**Bidder Questions and Answers Matrix for  
RFP No. 25-R21  
LANDSCAPING MAINTENANCE SERVICES**

# ATTACHMENT 1

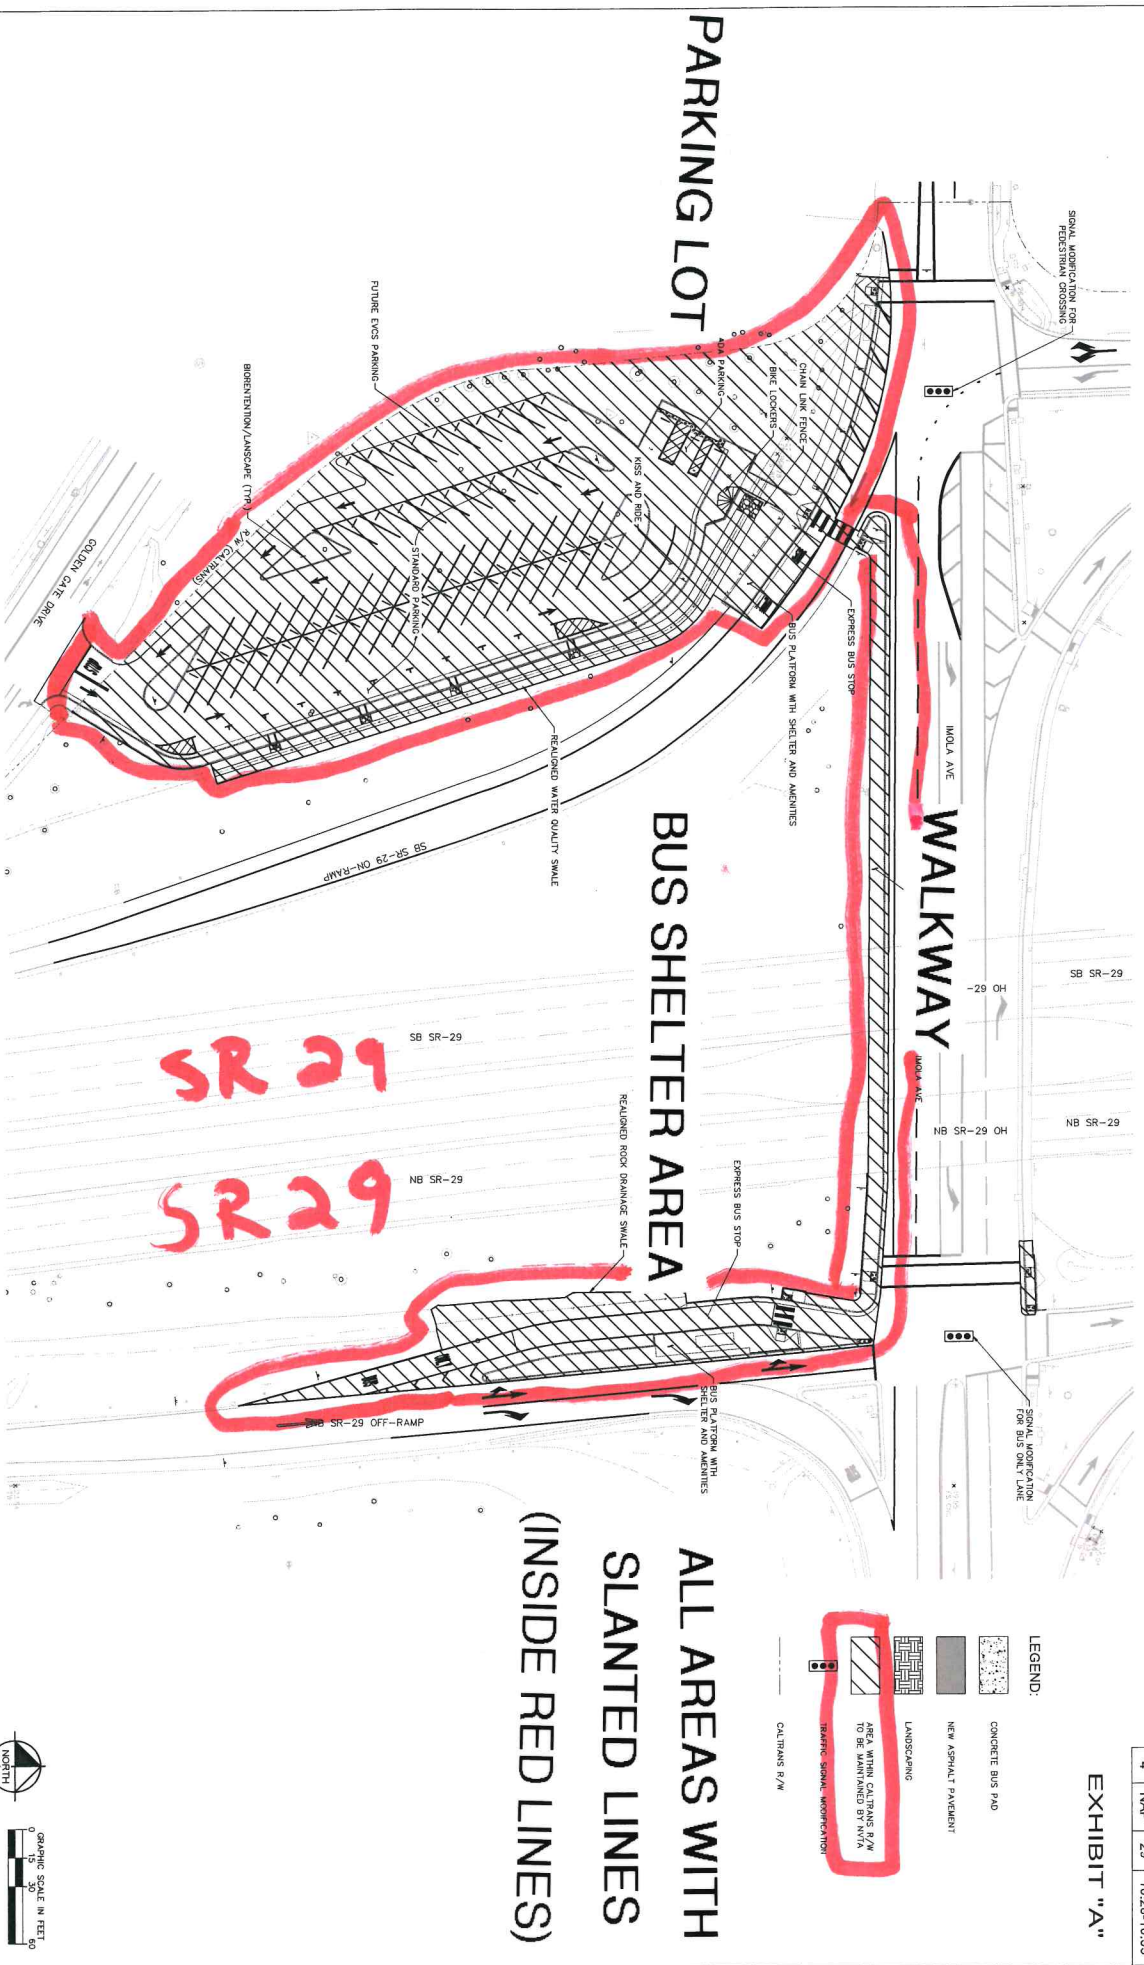
10.		When does the work commence?	<i>On May 1, 2025 or June 1, 2025.</i>
11.		We appreciate the blueprints for the sites. Would it be possible to provide maps with borders so we are certain of the area of service?	<i>See Attachment 1 labeled “Vine BMF Boundaries”, Redwood P&amp;R Boundaries, “SGTC NVTA Boundaries” and “Imola P&amp;R Boundaries” attached.</i>

SOSCOL GATEWAY TRANSIT CENTER/NVTA  
INSIDE RED LINES, USE FENCE LINE AS GUIDE  
WHERE AVAILABLE

**INSIDE RED LINES, USE FENCE LINE AS GUIDE WHERE AVAILABLE**

ALL AREAS WITH  
SLANTED LINES  
(INSIDE RED LINES)

REDWOOD PARK & RIDE INSIDE RED LINES, USE FENCE LINE AS GUIDE WHERE AVAILABLE
